UNITED STATES  
ATOMIC ENERGY COMMISSION  
WASHINGTON, D.C. 20545

Change No. 11  
License Nos. DPR-31 and 41

SAFETY EVALUATION FOR OPERATION OF TURKEY POINT UNITS 3 & 4

AT POWER LEVELS UP TO 100% OF RATED AND AT REDUCED PRIMARY SYSTEM PRESSURE

Figure 2.1-1. Reactor Core Thermal and Hydraulic Safety Limits, Three Loop Operation.

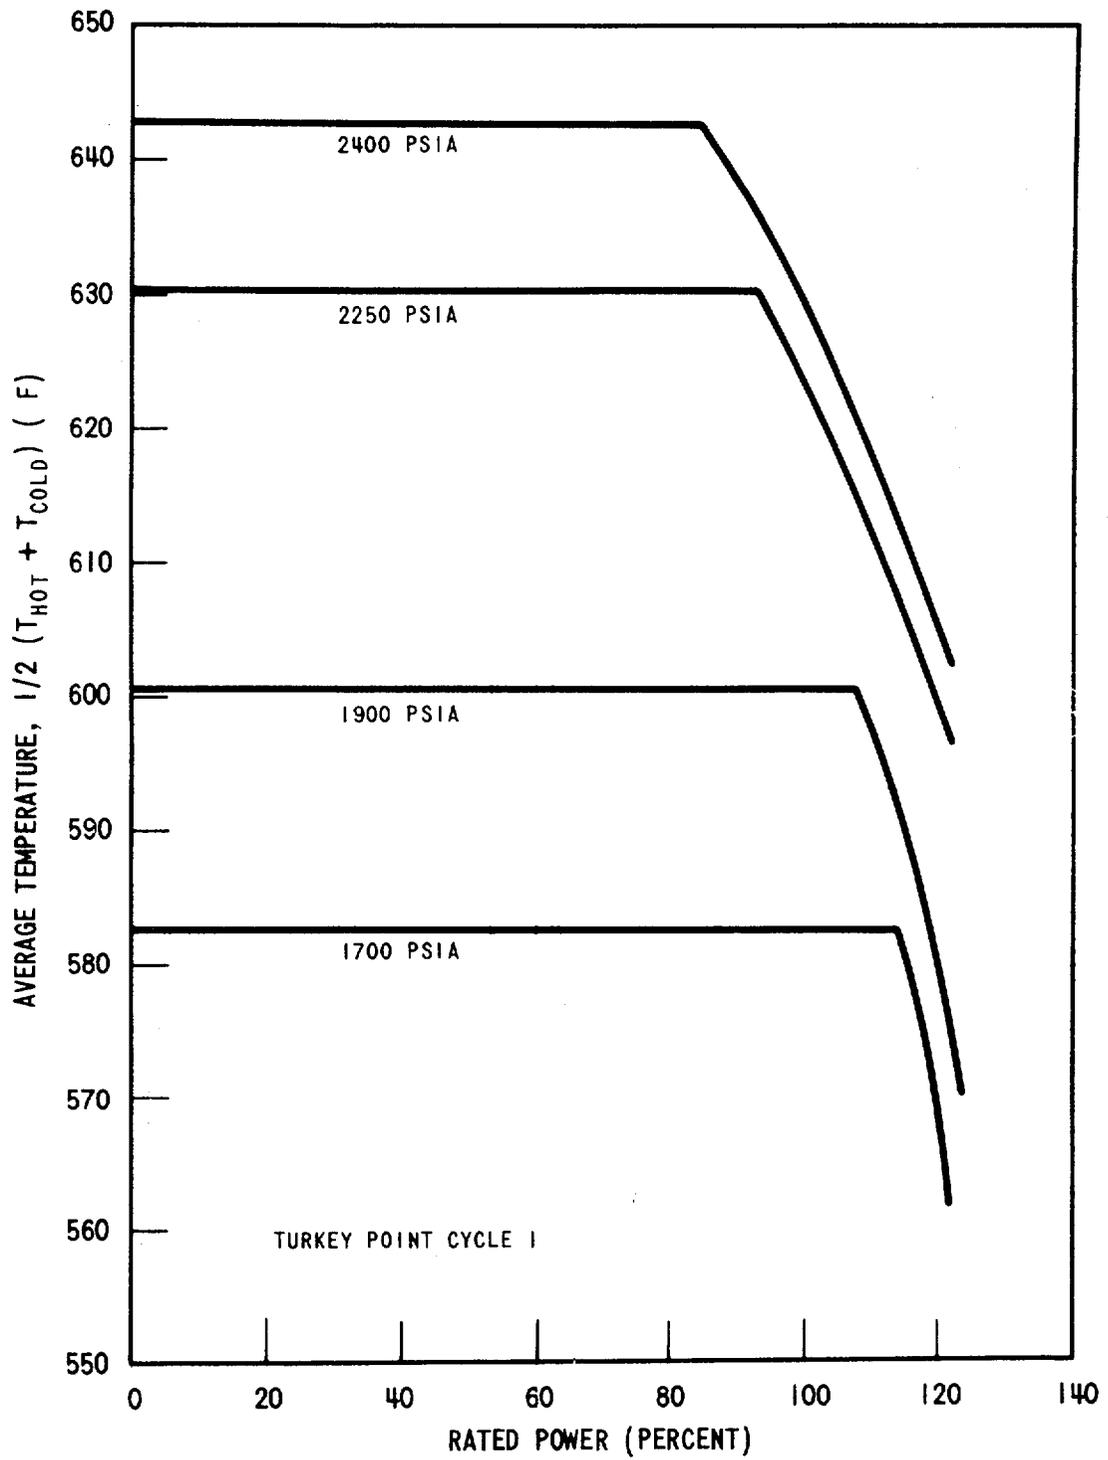
Changes to the limiting safety system settings have been made in Section 2.3 to reduce the low pressurizer pressure trip setting, and to revise the overtemperature and overpower  $\Delta T$  trip settings in accordance with revised Figure 2.1-1. Changes to Section 3.2, Control Rod and Power Distribution Limits, have been made to paragraph 6, Power Distribution Limits, to define the allowable operating power and required power distribution measurements in accordance with Figure 3.2-4.

Figures 2.1-1 and 2.1-2

These are replacement figures.

Figure 3.2-3 Maximum Allowable Operating Power Level versus Fuel Burnup

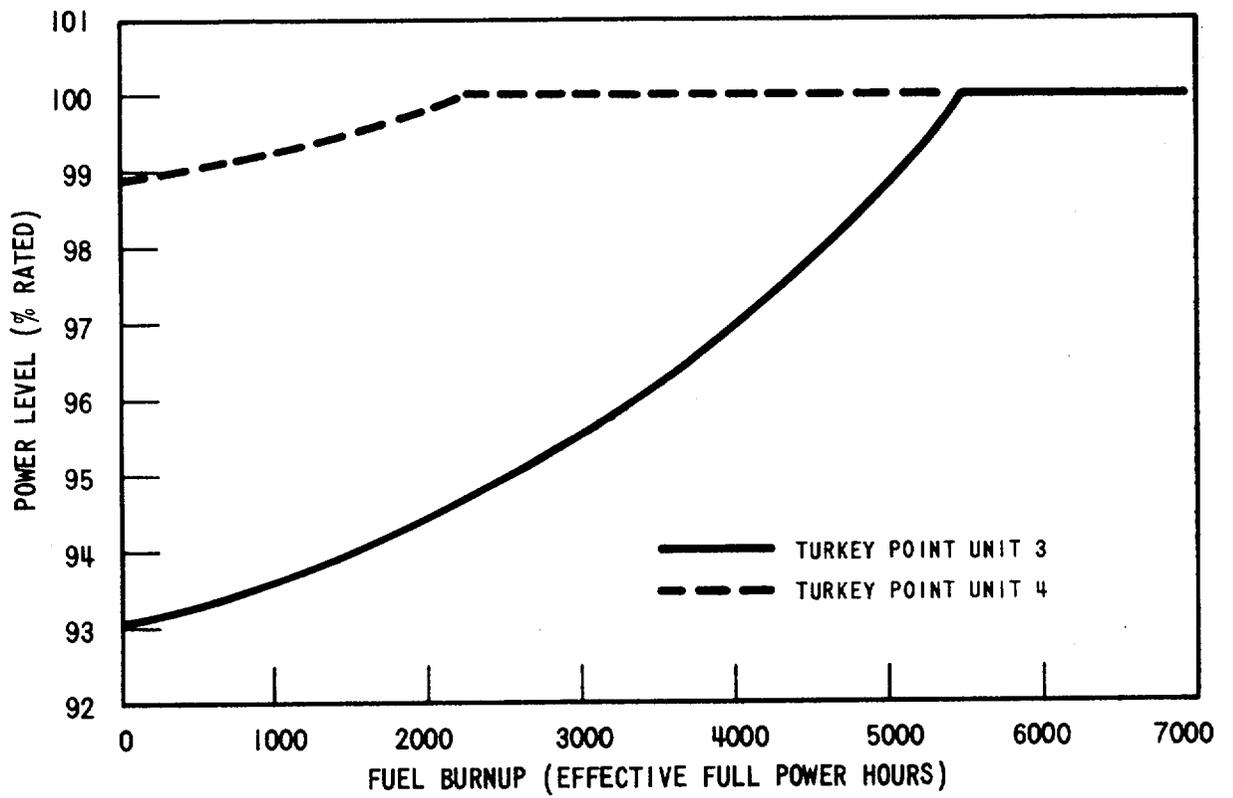
Figures 3.2-3 and 3.2-4

These are new figures.

- c. The permissible fraction of rated power, N, not to exceed the power levels given in Figure 3.2-3, at which the reactor can be operated shall be determined by

Figure 3.2-4. Maximum Allowable Local KW/FT

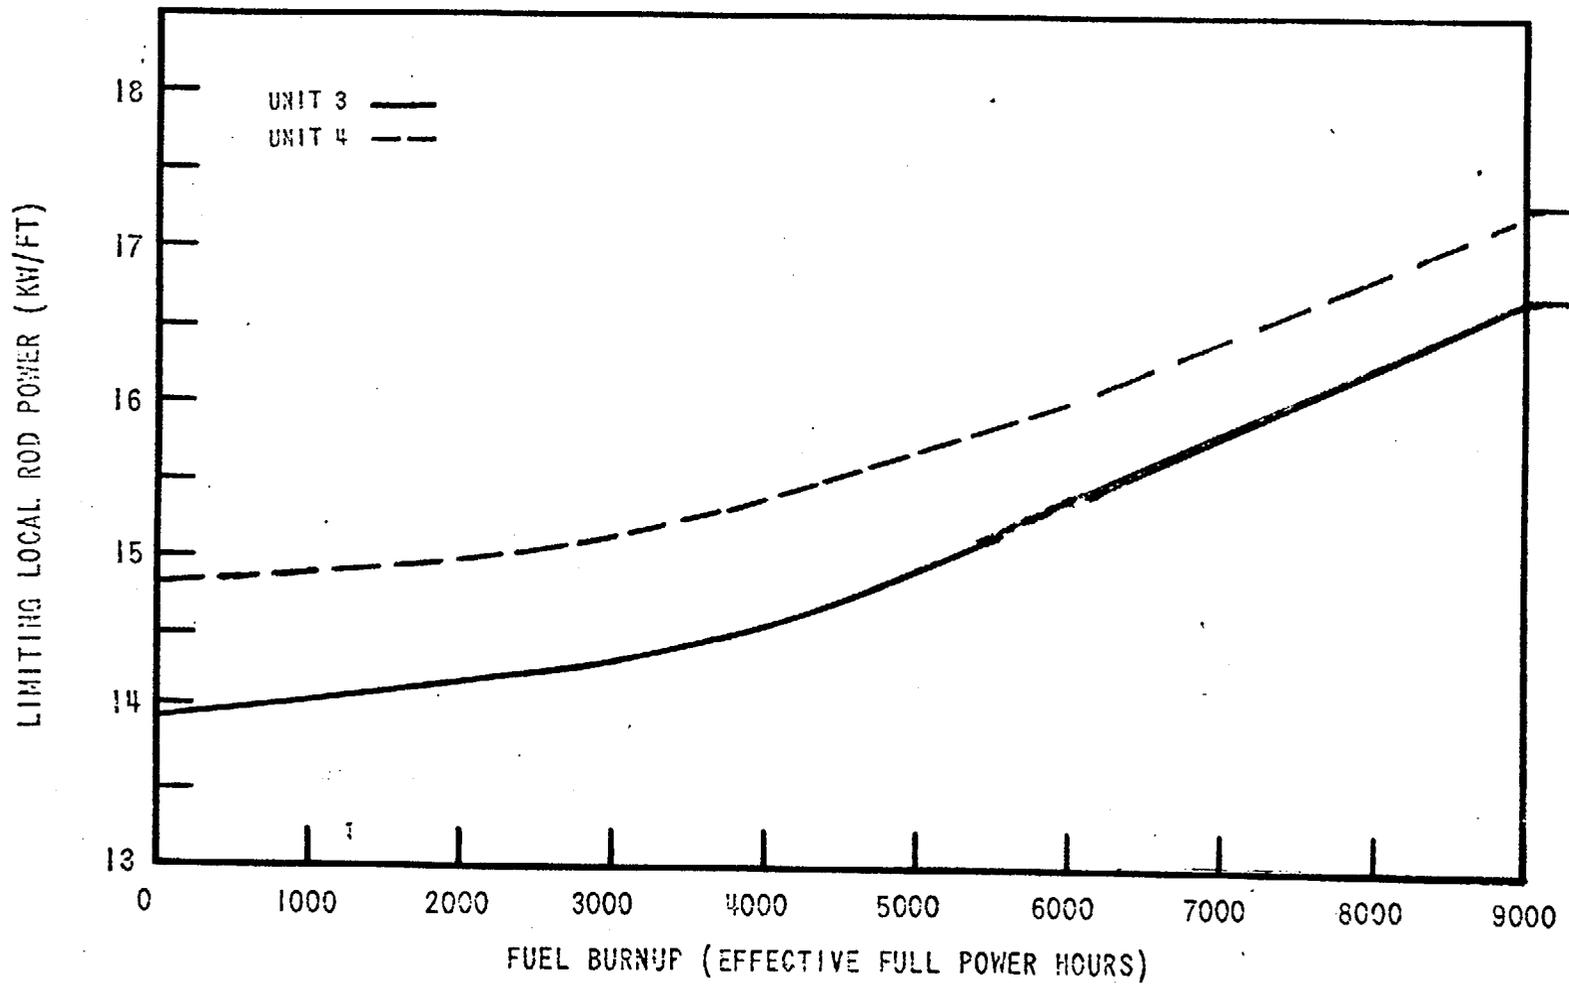
Q = limiting local power from Figure 3.2-4;
